# UNITED STATES PATENT AND TRADEMARK OFFICE

10/776,061

**Office Action Summary**

### **DETAILED ACTION**

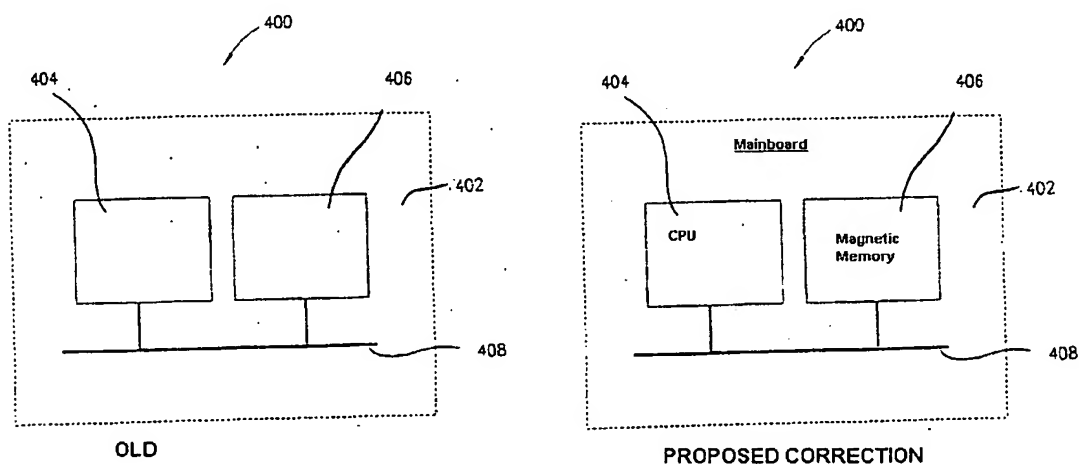
6. The drawings are objected to because the unlabeled rectangular box(es) shown in the drawings (Fig. 4) should be provided with descriptive text labels. For clarity purposes, Examiner suggests the following proposed correction for Figure 4:

Corrected drawing sheets in compliance with 37 CFR 1.121(d) are required in reply to the Office action to avoid abandonment of the application. Any amended replacement drawing sheet should include all of the figures appearing on the immediate prior version of the sheet, even if only one figure is being amended. The figure or figure number of an amended drawing should not be labeled as "amended." If a drawing figure is to be canceled, the appropriate figure must be removed from the replacement sheet, and where necessary, the remaining figures must be renumbered and appropriate changes made to the brief description of the several views of the drawings for consistency. Additional replacement sheets may be necessary to show the renumbering of the remaining figures. Each drawing sheet submitted after the filing date of an application must be labeled in the top margin as either "Replacement Sheet" or "New Sheet" pursuant to 37 CFR 1.121(d). If the changes are not accepted by the examiner, the applicant will be notified and informed of any required corrective action in the next Office action. The objection to the drawings will not be held in abeyance.
